UNITED STATES PATENT AND TRADEMARK OFFICE

APPLICATION NO.	FILING DATE	FIRST NAMED INVENTOR	ATTORNEY DOCKET NO.	CONFIRMATION NO.
10/616,039	07/09/2003	Roger Nolan	103681-112799	9796
7590 10/31/2005			EXAMINER	
Mark A. Taylo	or	WILKENS, JANET MARIE		
Stoll, Keenon & Park, LLP Suite 2100			ART UNIT	PAPER NUMBER
300 W. Vine St.			3637	
Lexington, KY	40507	DATE MAILED: 10/31/2005

Application No.	Applicant(s)			
	10/616,039	NOLAN, ROGER			
Office Action Summary	Examiner	Art Unit			
	Janet M. Wilkens	3637			
The MAILING DATE of this communication app Period for Reply	ears on the cover sheet with the c	orrespondence address			
A SHORTENED STATUTORY PERIOD FOR REPLY WHICHEVER IS LONGER, FROM THE MAILING DA - Extensions of time may be available under the provisions of 37 CFR 1.13 after SIX (6) MONTHS from the mailing date of this communication. - If NO period for reply is specified above, the maximum statutory period w - Failure to reply within the set or extended period for reply will, by statute, Any reply received by the Office later than three months after the mailing earned patent term adjustment. See 37 CFR 1.704(b).	ATE OF THIS COMMUNICATION 16(a). In no event, however, may a reply

[Attach ment A]

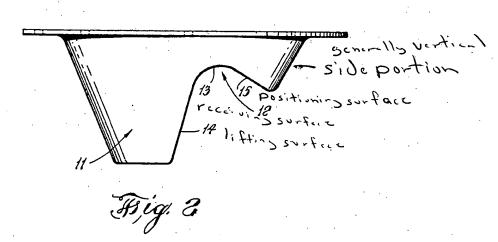
Addressing the arguments concerning the reference of Scaramuzzi: as discussed above in the art rejections, the examiner contends that Scaramuzzi does teaches all of the claimed limitations, including a recess defined by walls extending inwardly into the base member from a generally vertically oriented side portion thereof (see Attachment A). As for the lifting surface, the limitation defining this surface as generally horizontal

Furthermore, since a lifting device comes into contact with surface 14 while the pallet is lifted, this surface can be considered a "lifting surface".
